**KAWARTHA PINE RIDGE DISTRICT SCHOOL BOARD
PUR24-072-ITT
Hampton Junior Public school Classroom Refresh**

ADDENDUM NO. 2

Project No.: 24004
Date: April 24, 2024
Tender No.: PUR24-072-ITT
Project: **KAWARTHA PINE RIDGE DISTRICT SCHOOL BOARD
Classroom Refresh at Hampton Jr. Public School**

HM-01

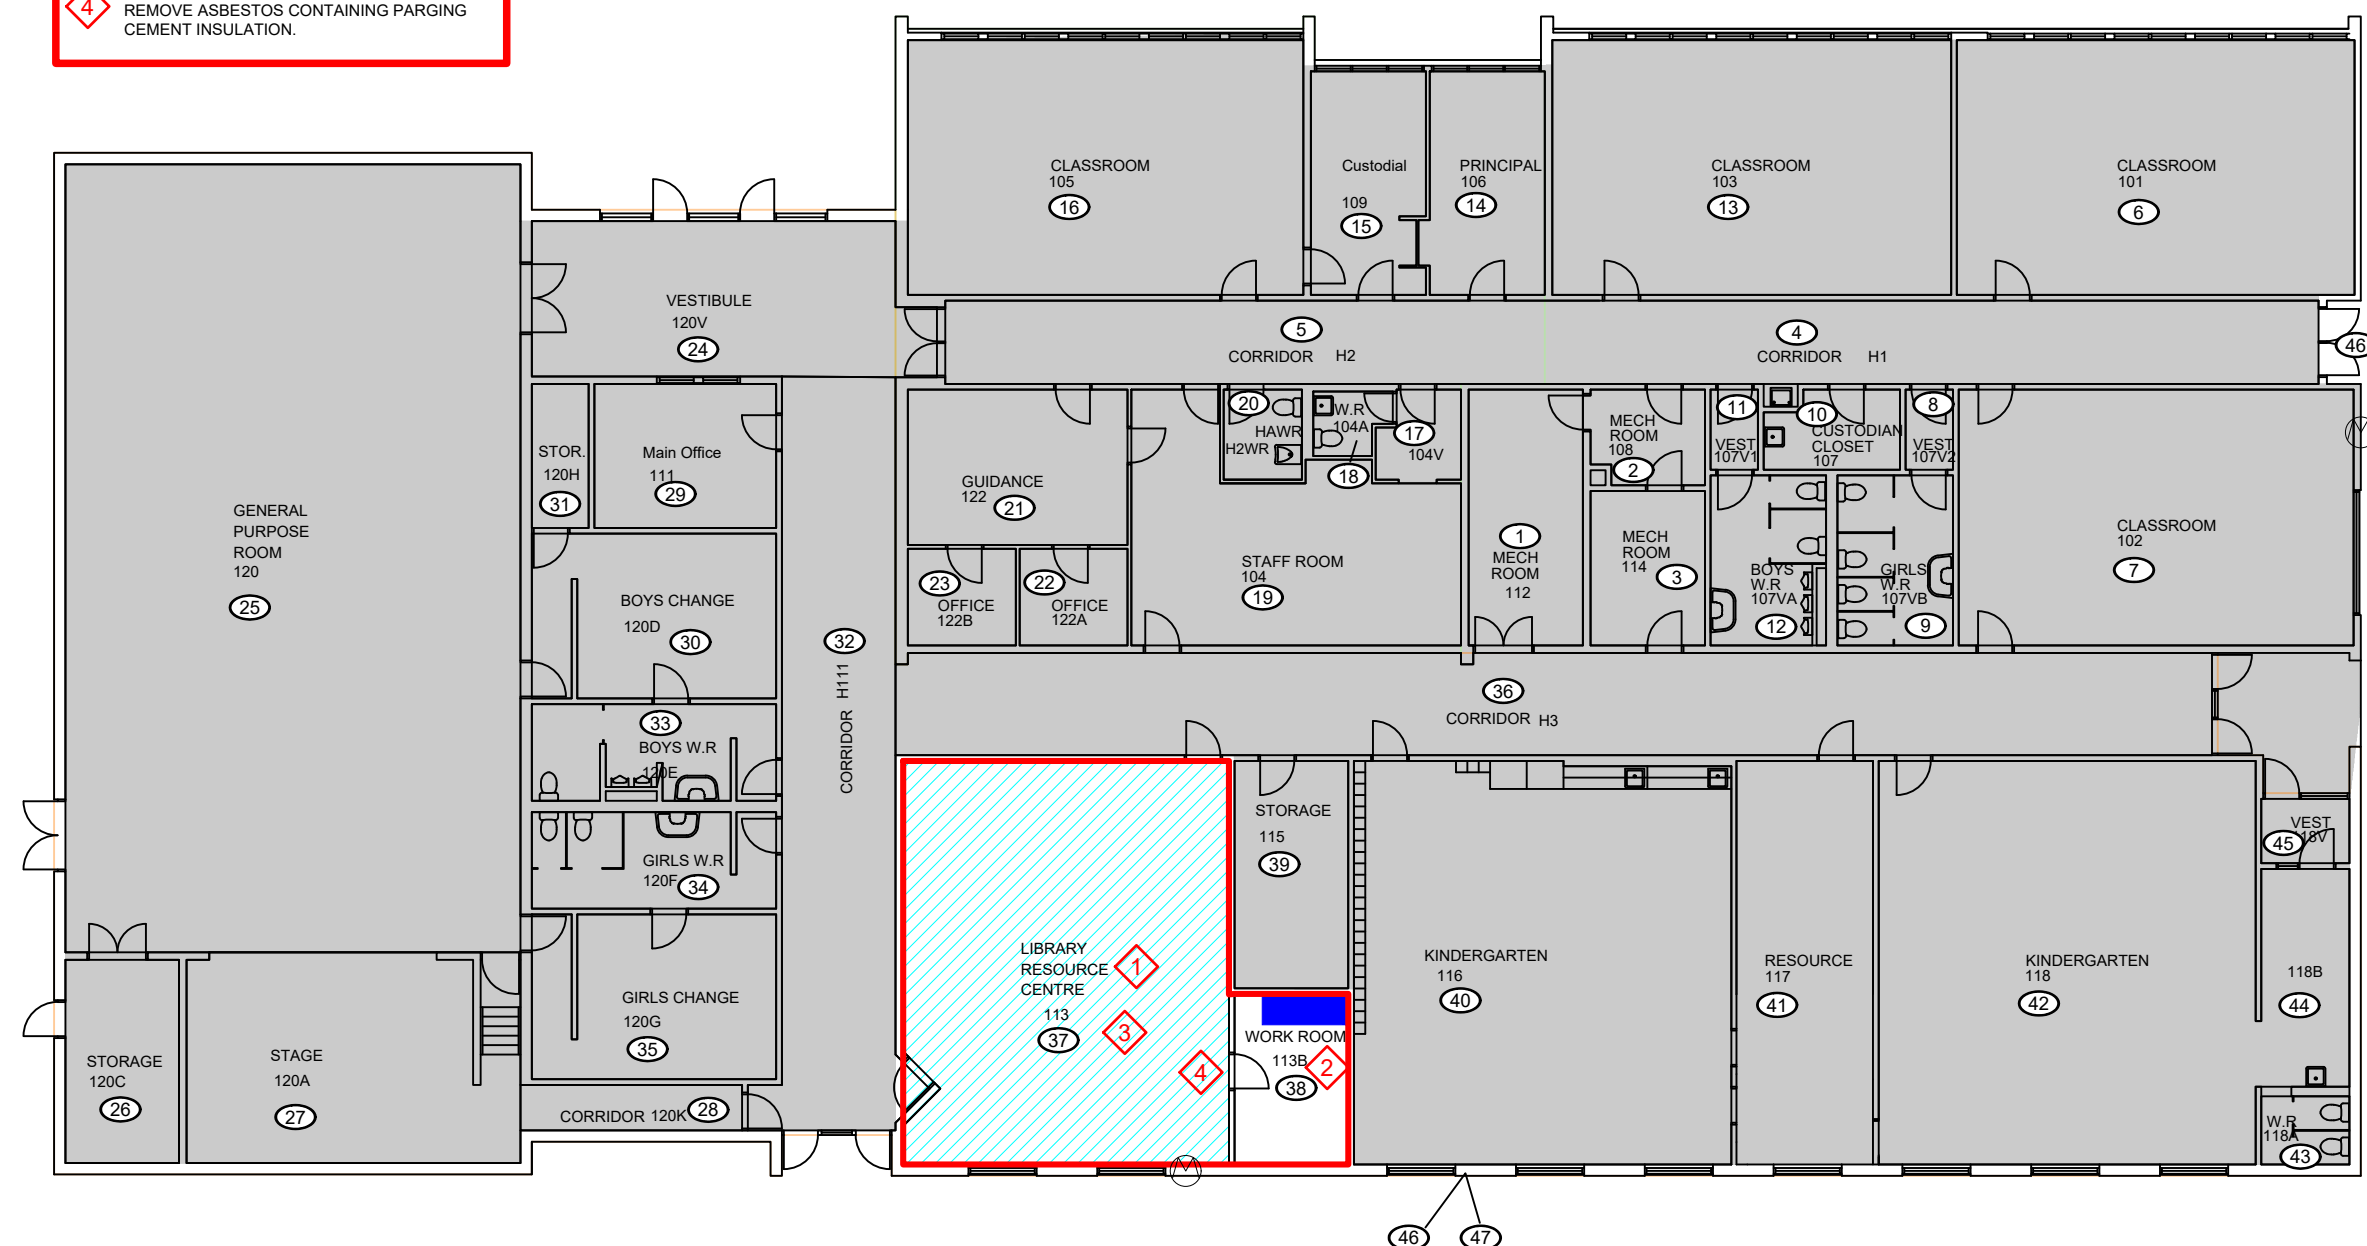
Question 1: Asbestos Scope of Work- Note 1 says to remove asbestos containing vinyl floor tile and levelling compound. The room currently has carpet installed. Please confirm that the abatement contractors are to remove carpet, floor tile and levelling compound complete as it will all be attached.

- .1 DRAWING HM-01 – Scope of Work
 - .1 Revise drawing note 1 to state removal of carpet.

Answer 1: The leveling compound was found in 2 out of 3 samples of the carpet mastic. These two samples came back as non-asbestos. Unfortunately, we need three samples to prove something is not asbestos containing. Similarly, to how we plan to sample the tack board mastics on the day that the school is empty, and we can start doing that type of demolition we would also like to sample the leveling compound to determine if it is non-asbestos. We would send the samples on 24 hours turn around hopefully getting results before abatement is scheduled to start. The thought is that by getting pricing now for having it removed as asbestos there is budget allocated for the removal and disposal of asbestos. Should the samples come back as non-asbestos disposal would be less, you may not need to pay the abatement crew for as much work, and there would be a cost savings since regular waste is less than asbestos waste disposal.

- 1 USING TYPE 1 PROCEDURES, REMOVE ASBESTOS CONTAINING LEVELING COMPOUND AND CARPET.
- 2 USING TYPE 1 PROCEDURES, REMOVE SINKS WITH ASBESTOS CONTAINING MASTICS.
- 3 USING TYPE 1 PROCEDURES, REMOVE TACKBOARDS AND ASSOCIATED ASBESTOS CONTAINING MASTICS.
- 4 USING TYPE 2 GLOVE BAG PROCEDURES, REMOVE ASBESTOS CONTAINING PARGING CEMENT INSULATION.

**DRAWING NO:
SK-01**

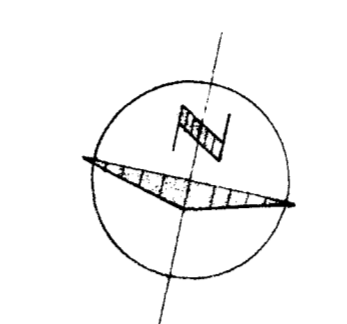
1.11 **Question:** If slab on grade repair require dowels and welded wire mesh, please specify requirements.

Answer: Refer to the attached SK-01 Typ. Slab to Slab Connection Detail.
